DETAIL ROADWAY PLAN

Kaneohe Bay Drive Improvements
Vicinity of Puohala Street to Kawa Bridge
Federal Aid Project No. STP-065-1(9)

2/3/03	Revised Driveway Per Adendum No. 1
--------	------------------------------------

ADD. 43

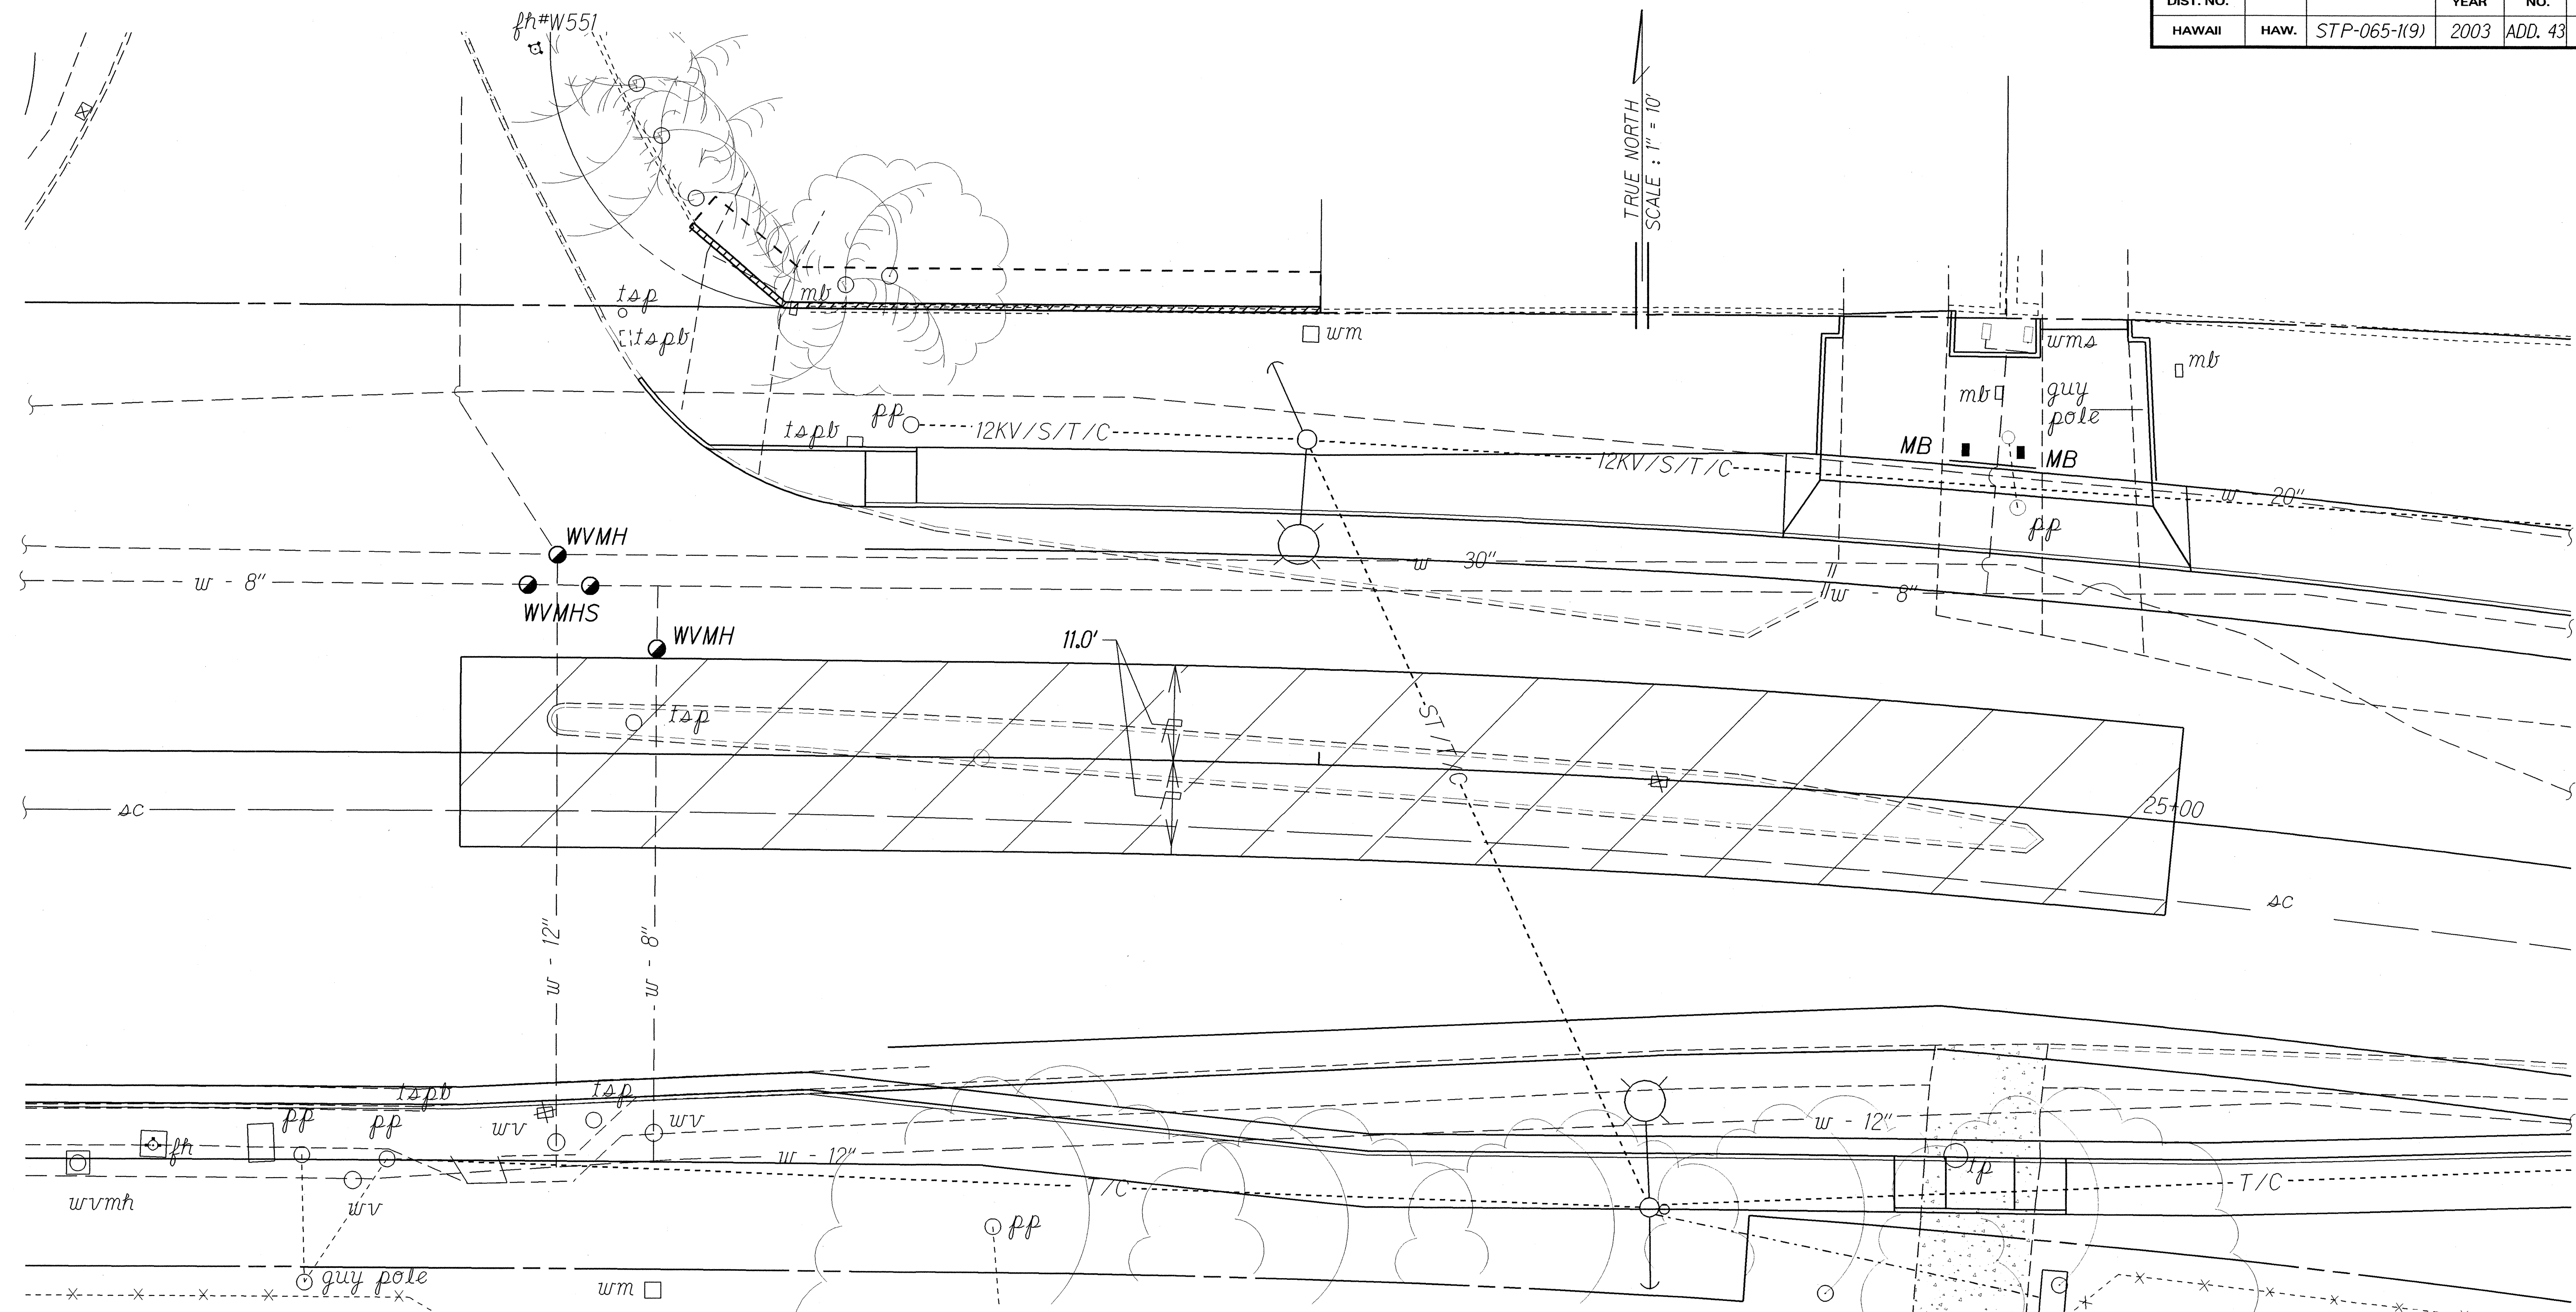
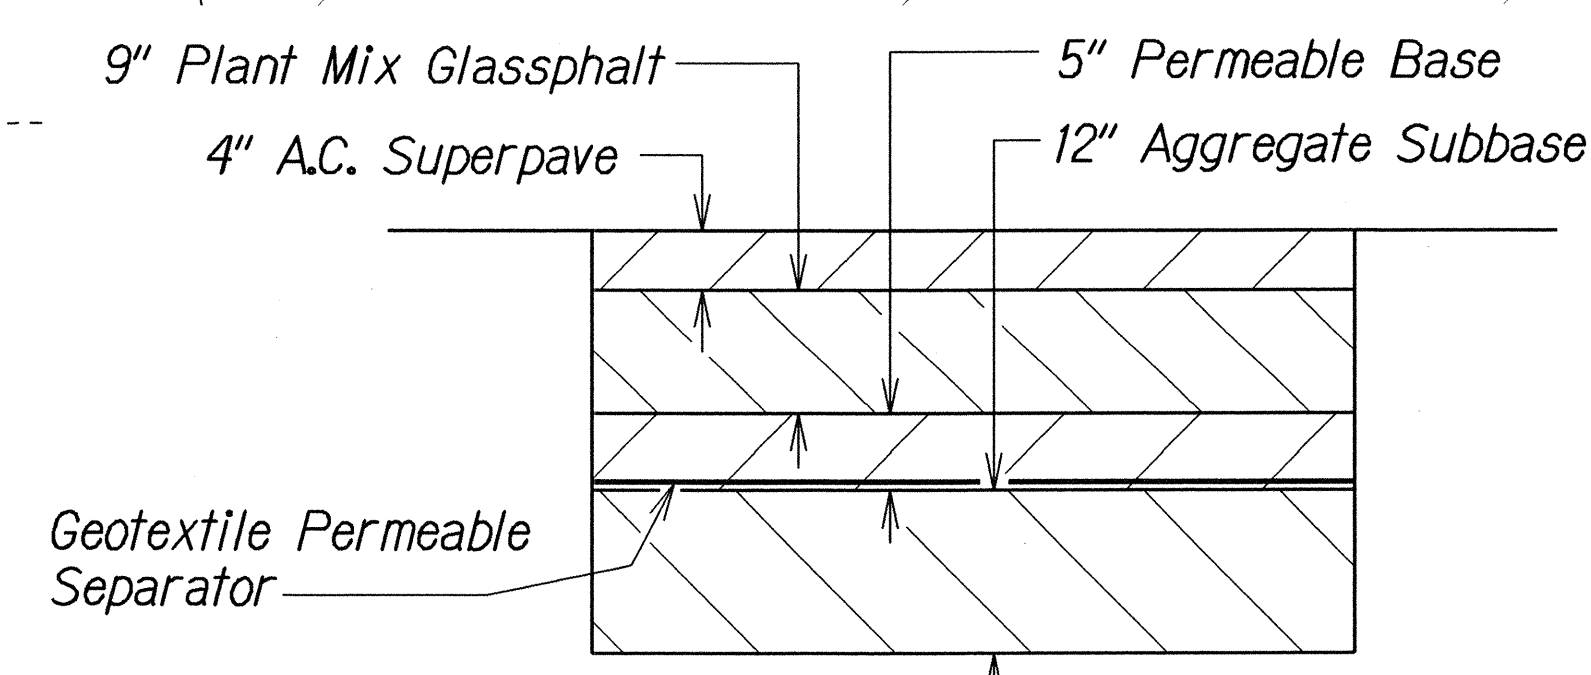
2/3/03 Revised Driveway per Addendum No. 1

Sta. 23+00 to # Sta. 25+00
 Remove Existing Island (2.5' Below
 New Pavement Grade) and Restore
 with New Pavement Structure. For
 Pavement Structure Detail, See this
 Sheet.
